ADDENDUM NO. 1

HC Wheatley Institute 3<sup>rd</sup> Floor

## **Project: Wheatley Institute – 3<sup>rd</sup> Floor Renovation**

### **ADDENDUM NO. 1**

**M9243**  
**M1.0**

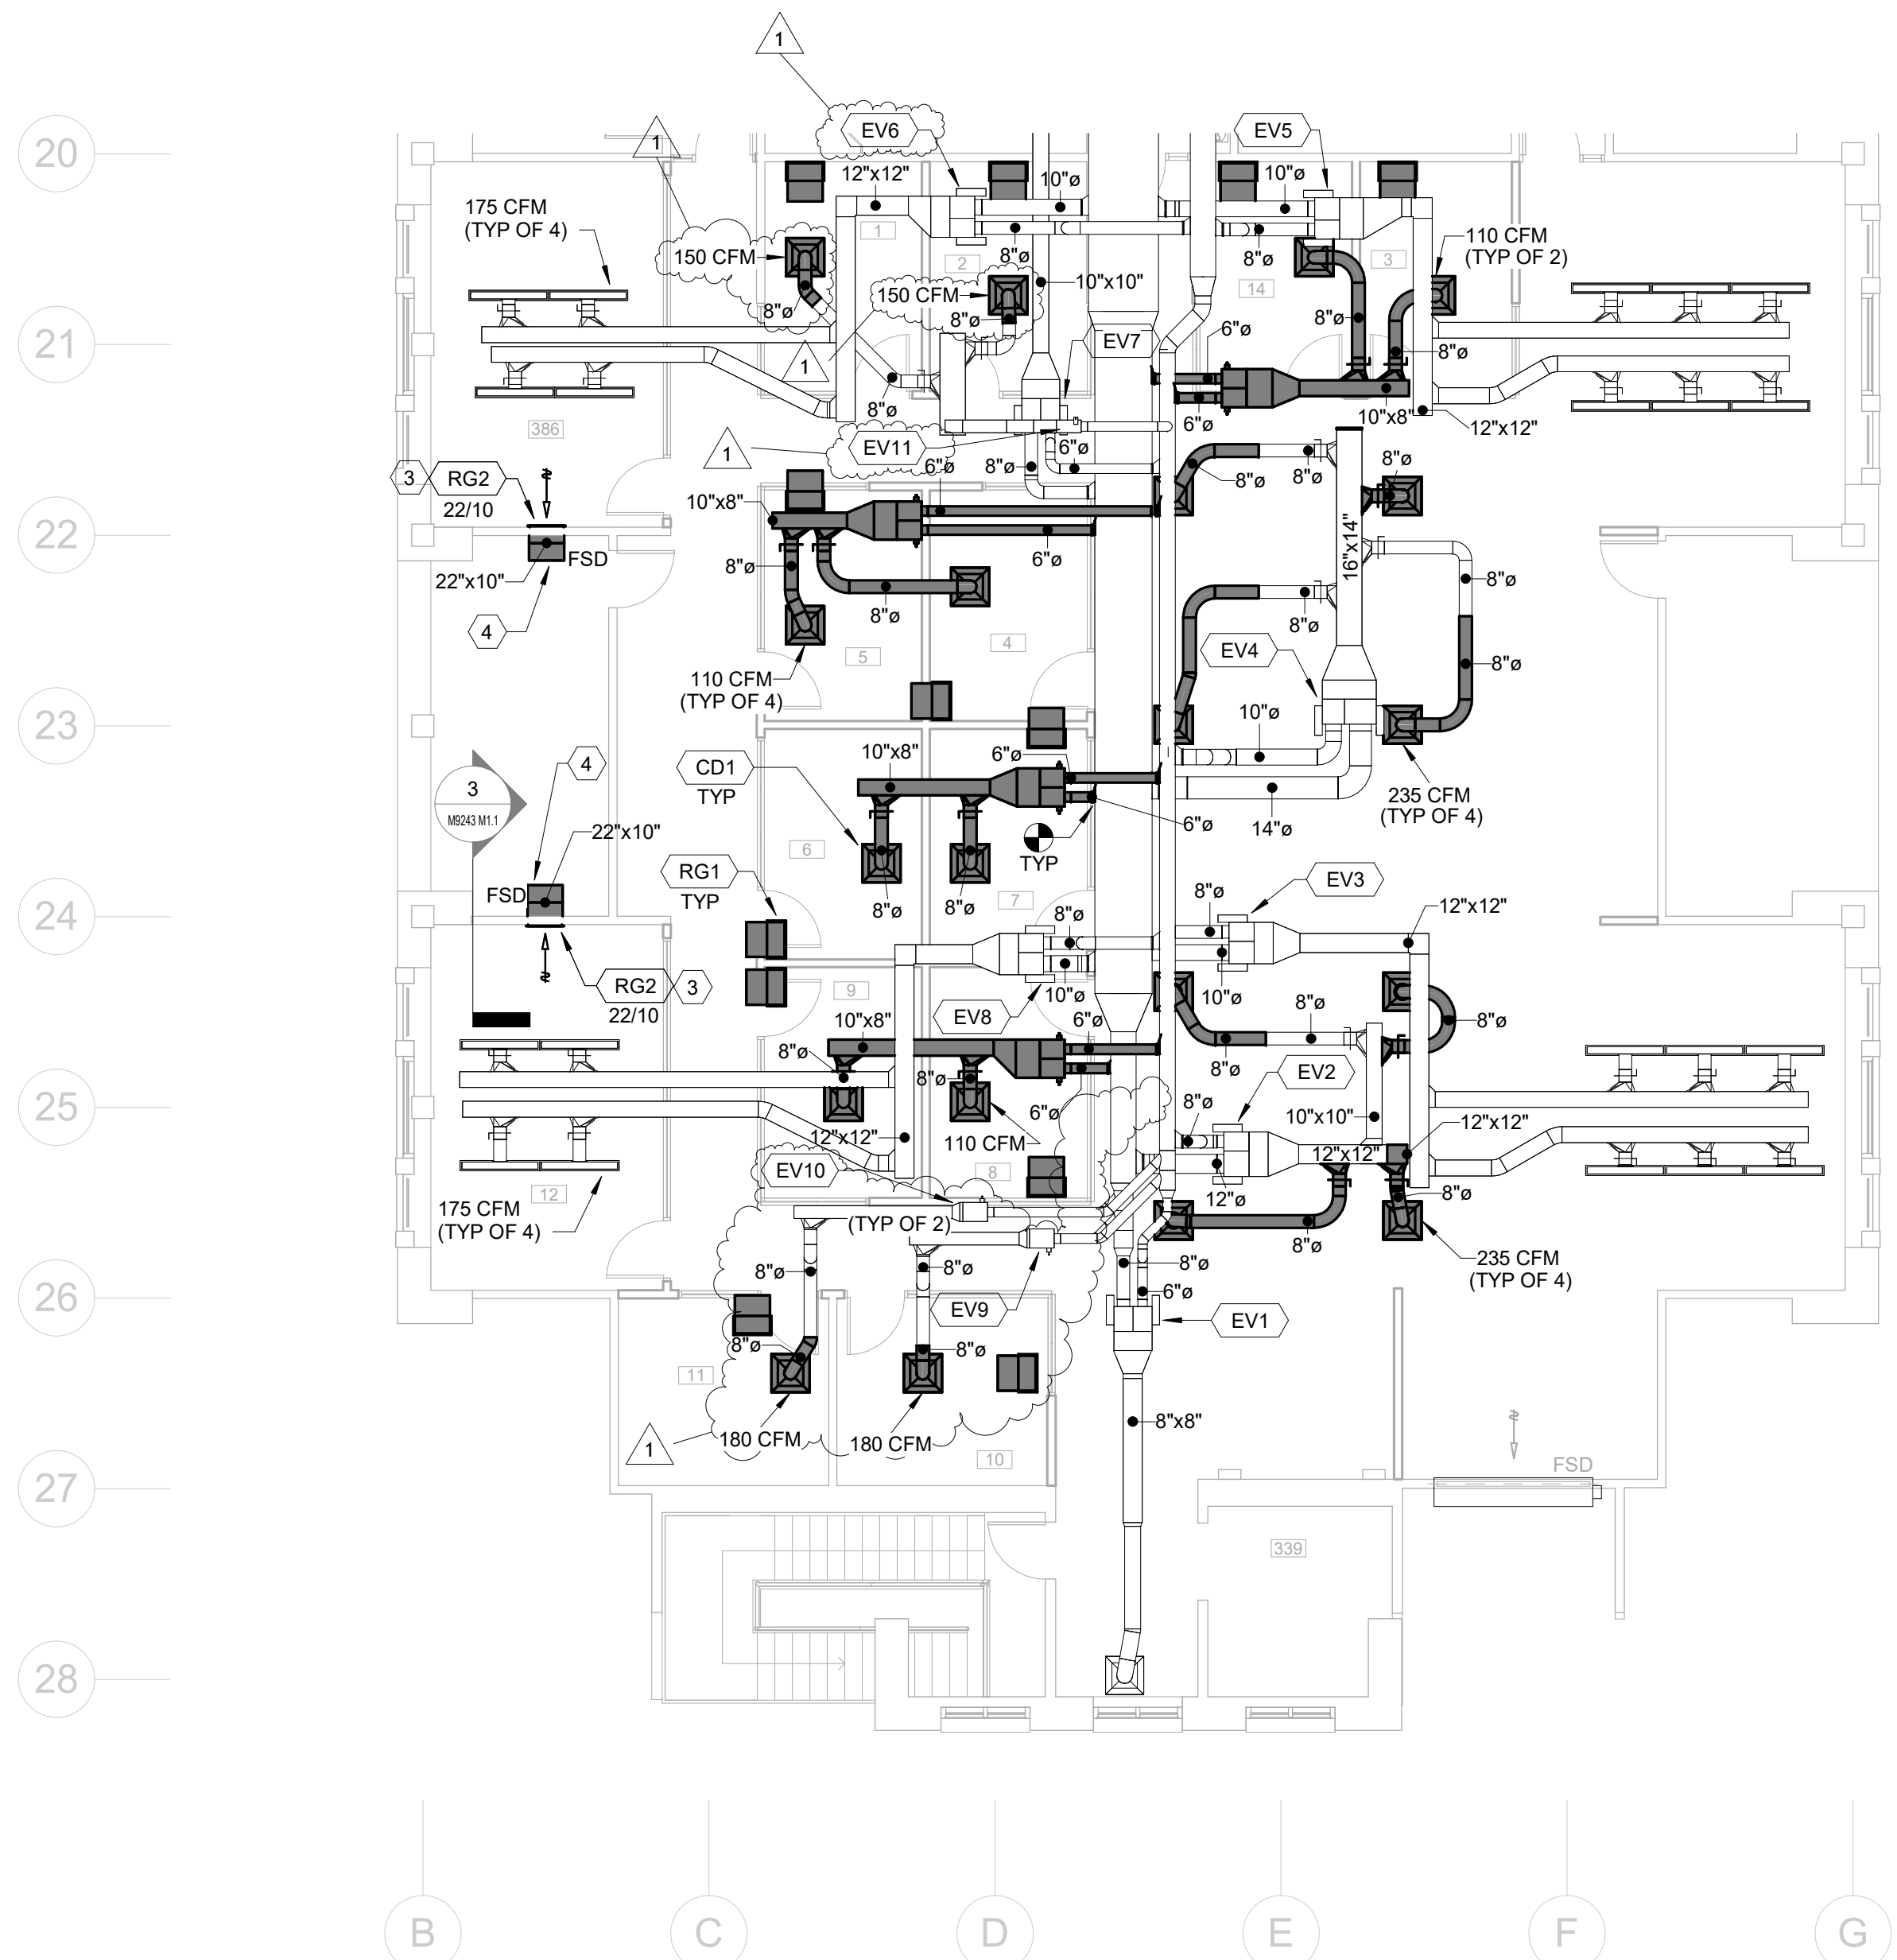
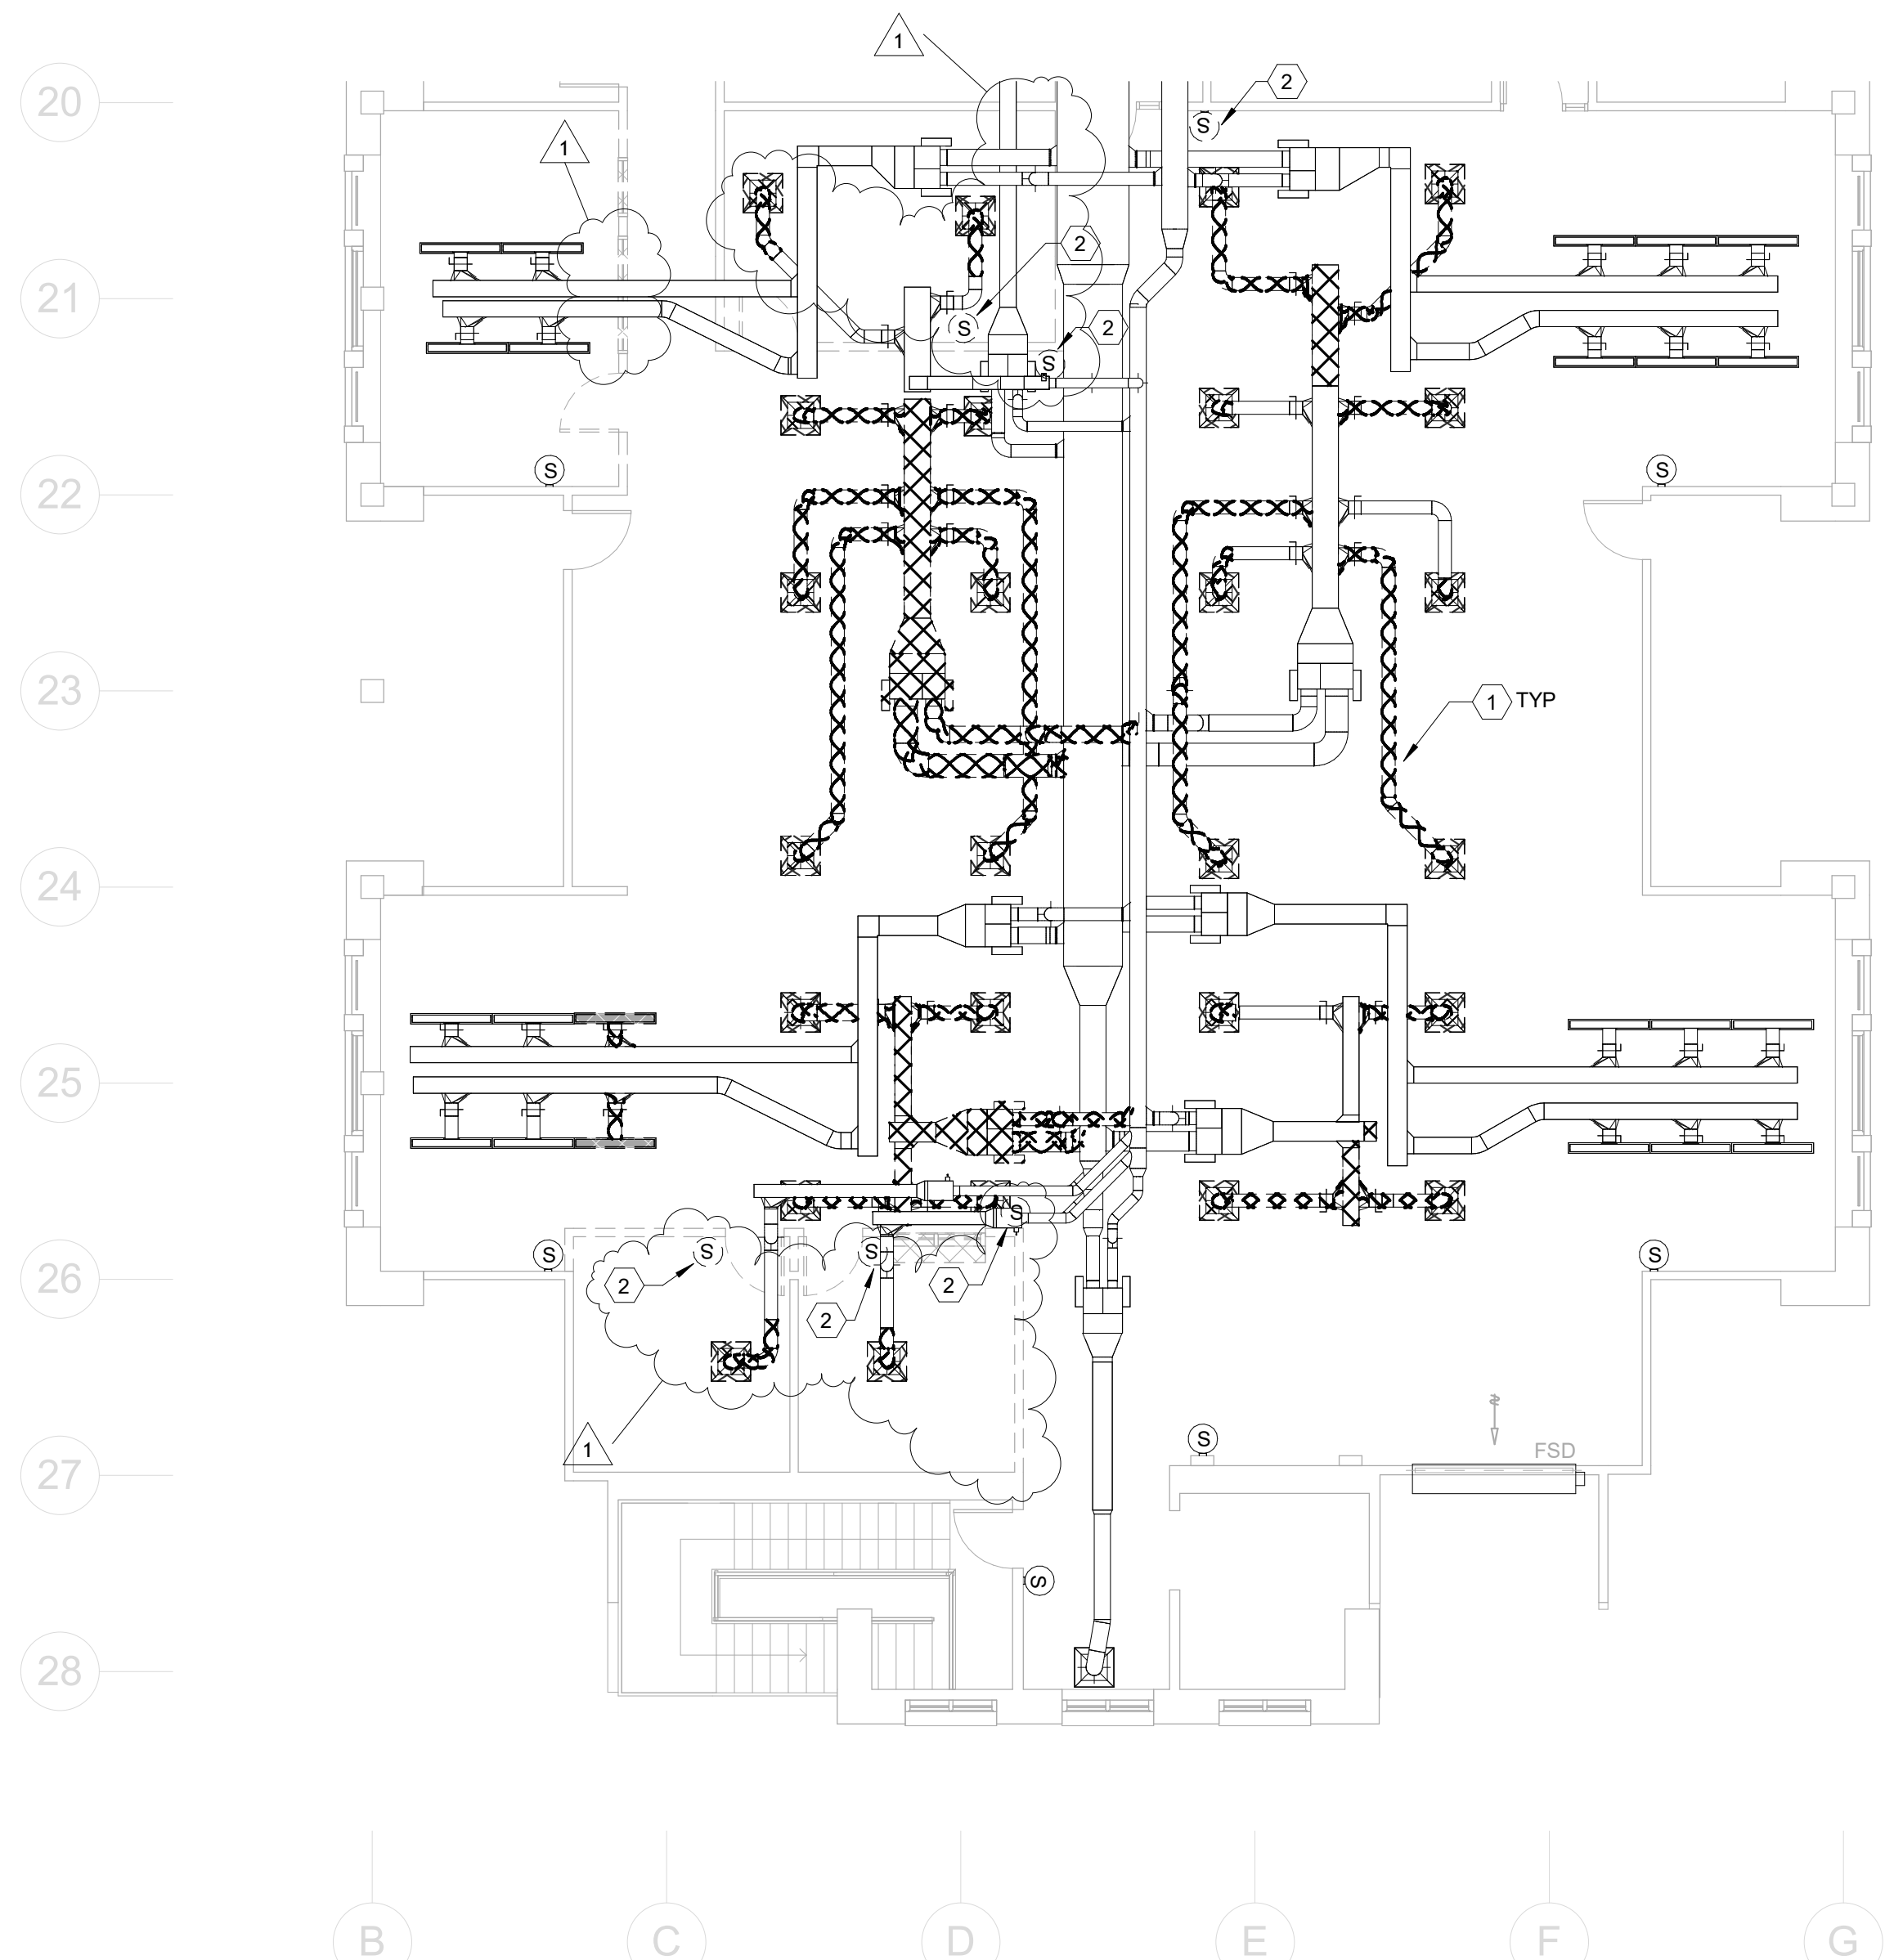
#### **9. Sheet M1.0:**

- ADD: General notes 9, 10, 11, & 12 to clarify scope.
- REVISE: Demo and new mechanical plan layouts based on information provided in the new General Notes.

**M9243 MECHANICAL CONTROLS PLAN**  
SCALE: 1/8" = 1'-0" **2**

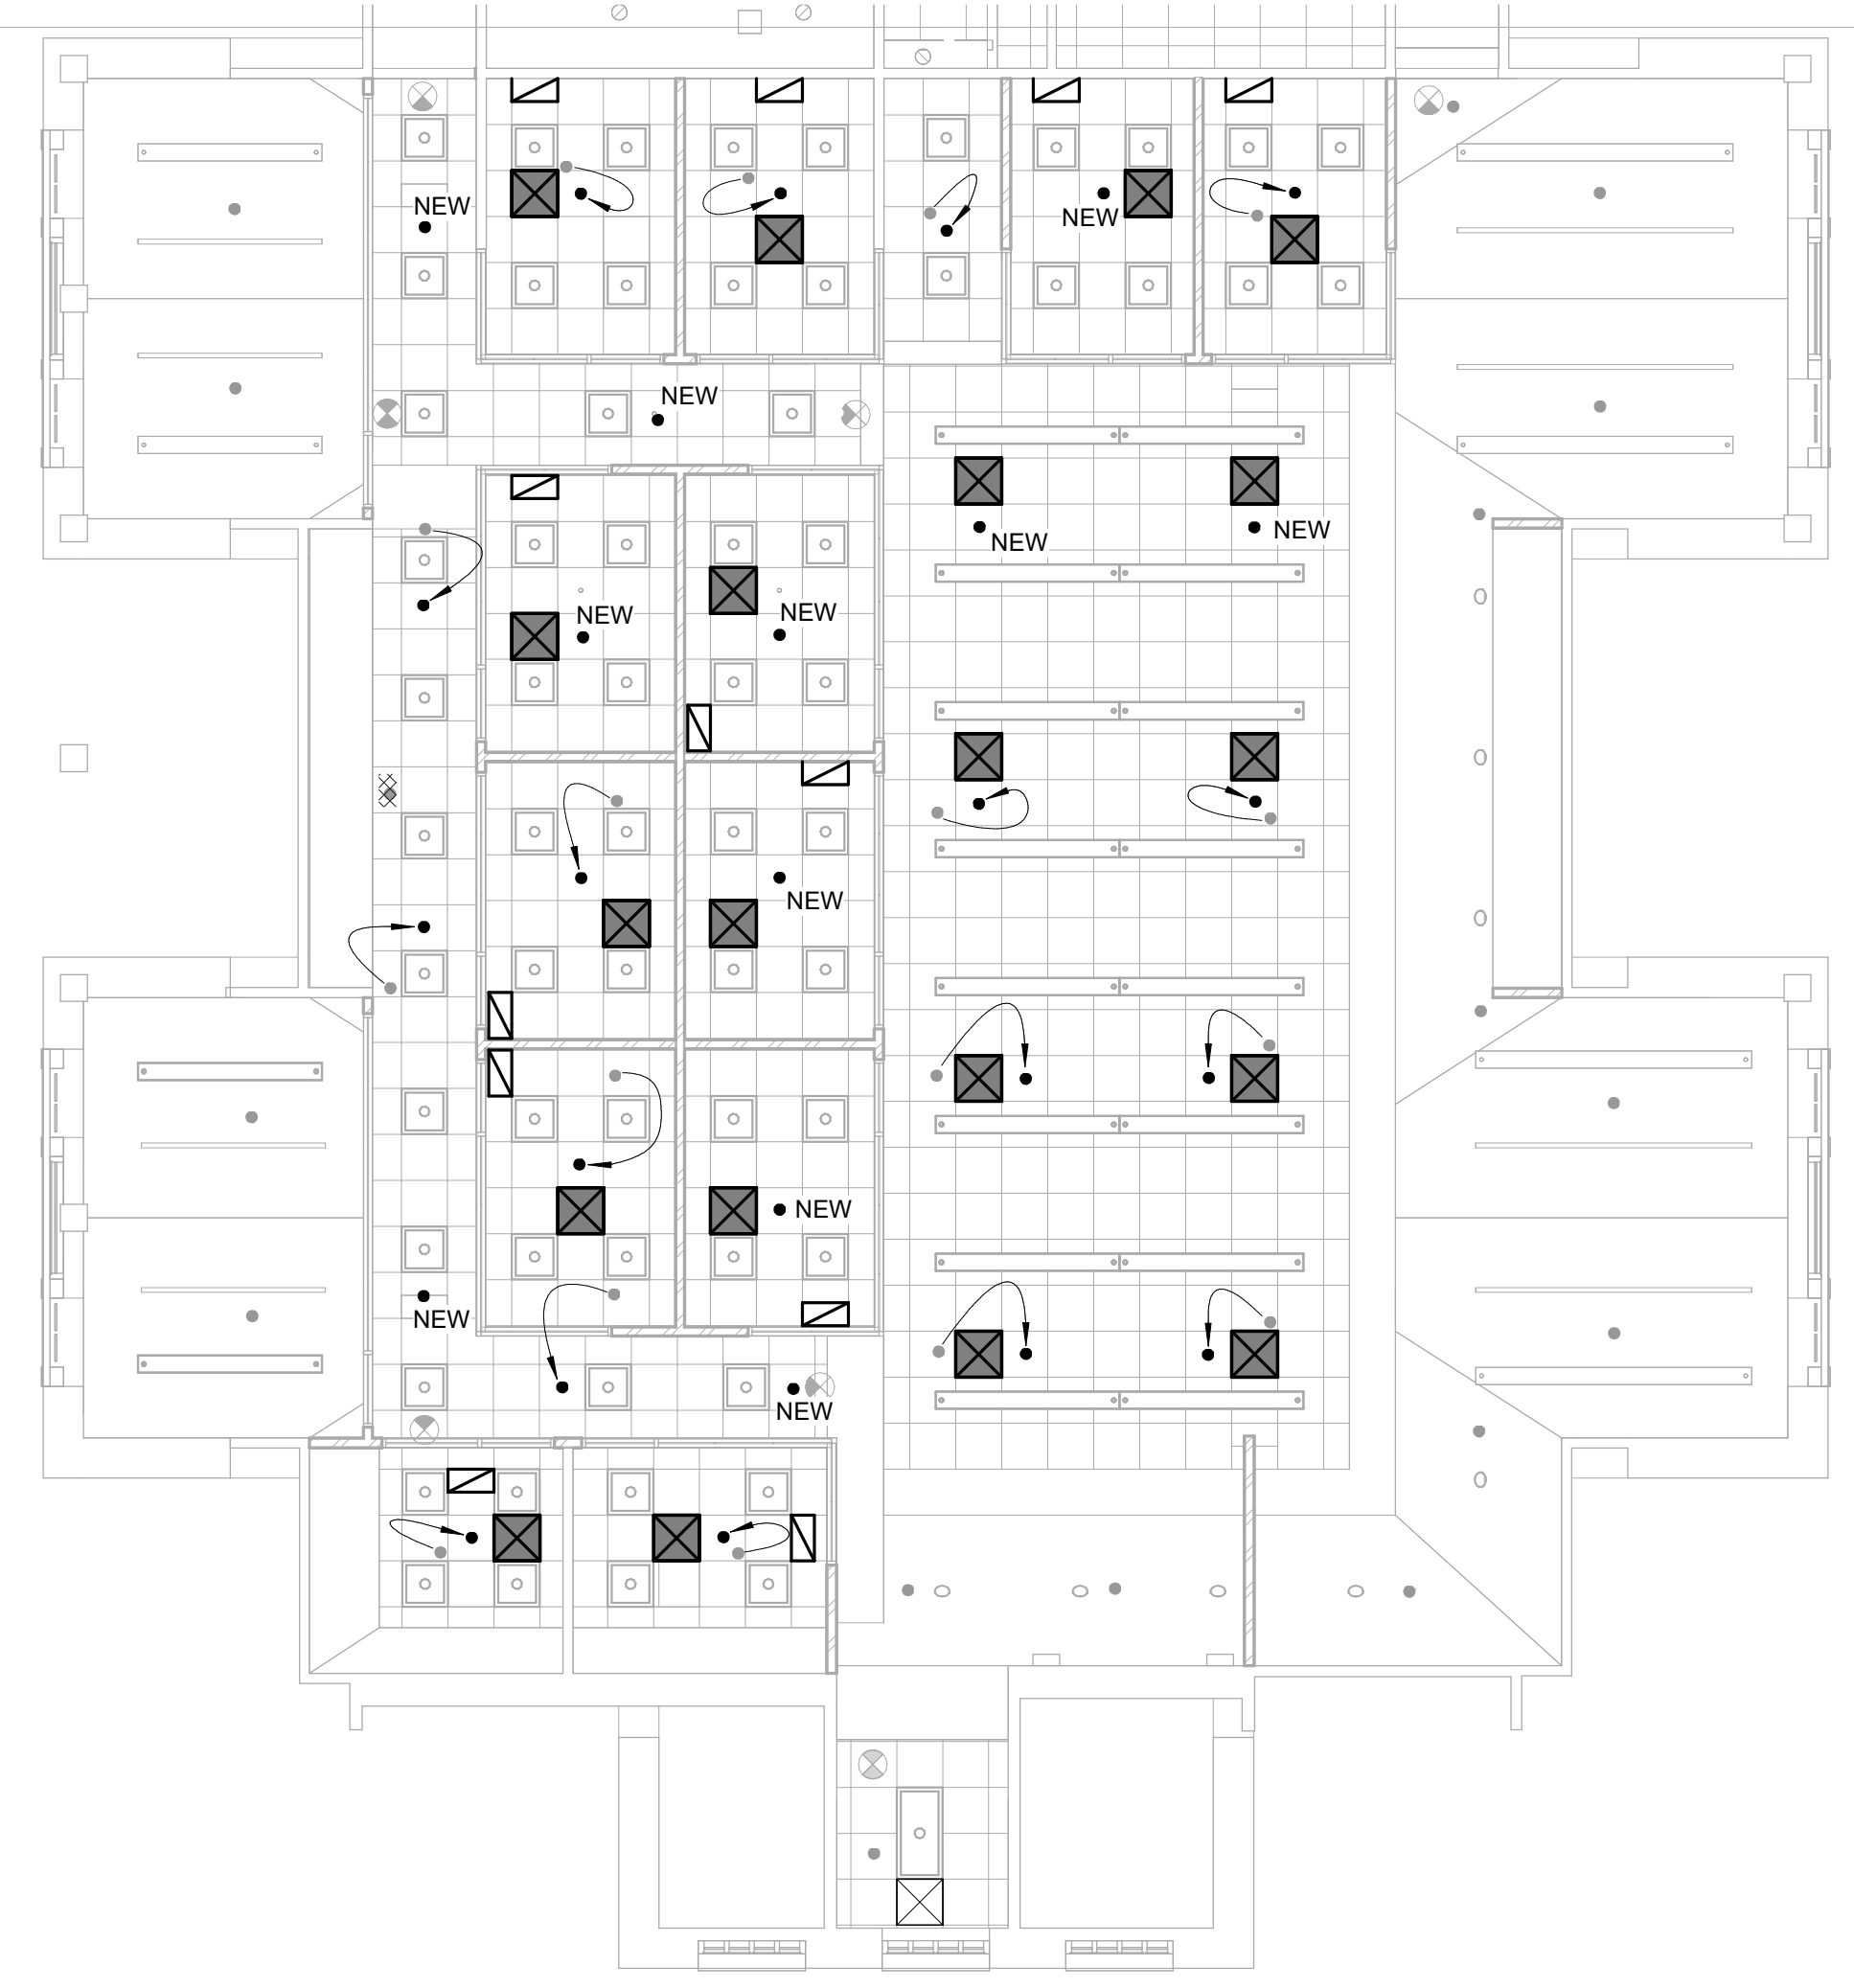
#### **10. Sheet M1.1:**

- ADD: General note 3 to clarify scope.
- REVISE: Drawing 2 Mechanical Controls plan based on information provided in the new General Note and HVAC controls detail on sheet M0.1.
